The Commission has issued the enclosed Amendment No. 38 to Facility License No. DPR-38; Amendment No. 38 to Facility License No. DPR-47; and Amendment No. 35 to Facility License No. DPR-55 for the Oconee Nuclear Station. These amendments consist of changes to the Station's common Technical Specifications and are in response to your request dated October 1, 1975.

These amendments revise the common Oconee Station Technical Specifications to incorporate changes to the Oconee Unit 1 pressurization, heatup, and cooldown limitations.

ATTACHMENT TO LICENSE AMENDMENTS

SAFETY EVALUATION BY THE OFFICE OF NUCLEAR REACTOR REGULATION

Figure 3.1.2-1A

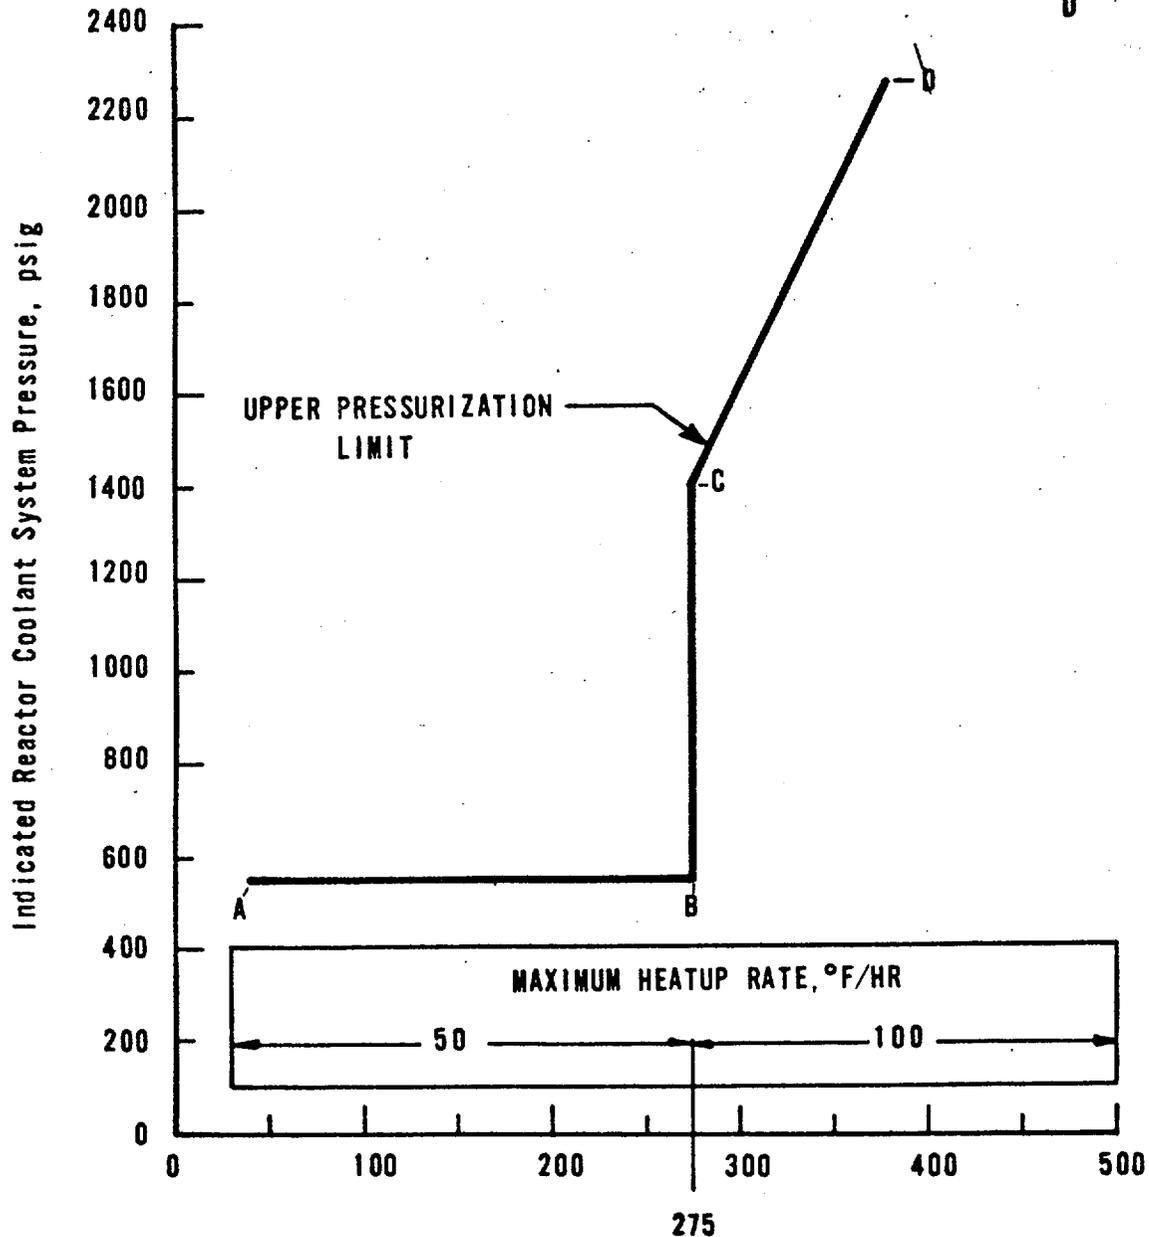
The Oconee Unit 1 pressure-temperature operating limit curves, Figures 3.1.2-1A, 3.1.2-2A and 3.1.2-3 are based on calculations for operation through 5 effective full power years (EFPY). These curves were prepared based on data from a Babcock & Wilcox Report, "Analysis of Capsule OC1-F From Duke Power Company Oconee Unit 1 Reactor Vessel Materials Surveillance Program," BAW-1421 Revision 1, dated September 1975.

We have reviewed BAW-1421, Revision 1 and the proposed pressure-temperature operating limit curves. The data does not adequately support the use of these curves for 5 EFPY. We have, therefore, performed independent calculations based on the methods of Regulatory Guide 1.99. Based on our independent calculations and our review of BAW-1421, we have concluded however, that the use of these curves is acceptable through 4 EFPY.

Following discussion with the licensee, the amendment has been prepared reflecting this limitation.
